APPLICATION NO.	FILING DATE	FIRST NAMED INVENTOR	ATTORNEY DOCKET NO.	CONFIRMATION NO.
10/596,022	05/25/2006	Toshiharu Furukawa	FIS920030339US1	1812
32074 7590 03/08/2010 INTERNATIONAL BUSINESS MACHINES CORPORATION DEPT. 18G BLDG. 321-482 2070 ROUTE 52 HOPEWELL JUNCTION, NY 12533			EXAMINER GEBREYESUS, YOSEF	
			ART UNIT 2811	PAPER NUMBER
			NOTIFICATION DATE 03/08/2010	DELIVERY MODE ELECTRONIC

Office Action Summary	Application No. 10/596,022	Applicant(s) FURUKAWA ET AL.	
	Examiner YOSEF GEBREYESUS	Art Unit 2811

DETAILED ACTION

Fig. 1F

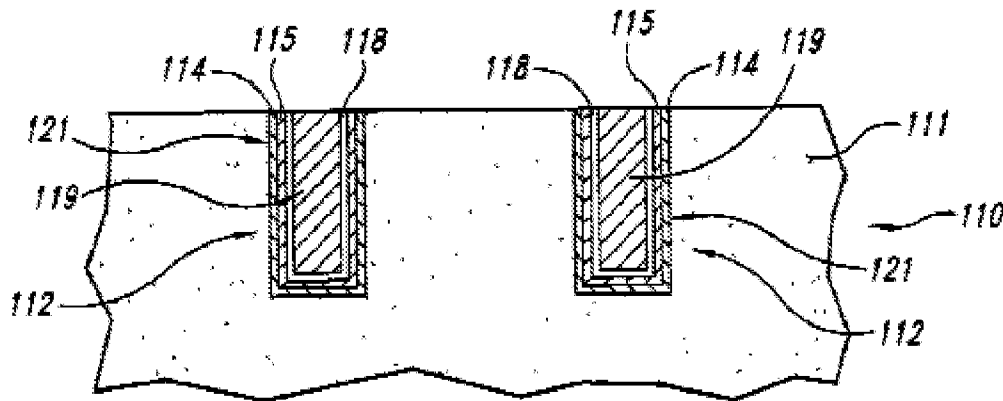
26. Regarding **claim 1**, figure 1A-1F and related text of Lee et al. discloses a substrate 110; a trench in said substrate; conductive material 115 (paragraph [0021]) lining said trench; and a trench conductor (conductive electrode) 119 (paragraph [0023]), surrounded by said conductive material filling said trench (paragraph [0022]), wherein said trench conductor (conductive electrode) 119 (paragraph [0023]) and said substrate 110 having a co-planar top surface.

Lee et al. does not disclose the conductive material is a multiple conductive carbon nanotubes.

However, in the same field of endeavor figure 1 of Lee teaches using multiple conductive nanotubes 100 as a capacitor electrode (paragraph [0024]).

Therefore, it would have been obvious to one of ordinary skill in the art at the time the invention was made to replace the conductive material 115 of Lee et al.'s device with multiple carbon nanotubes as taught by Lee in order to increase the storage capacity of the capacitor (paragraph [0006]).
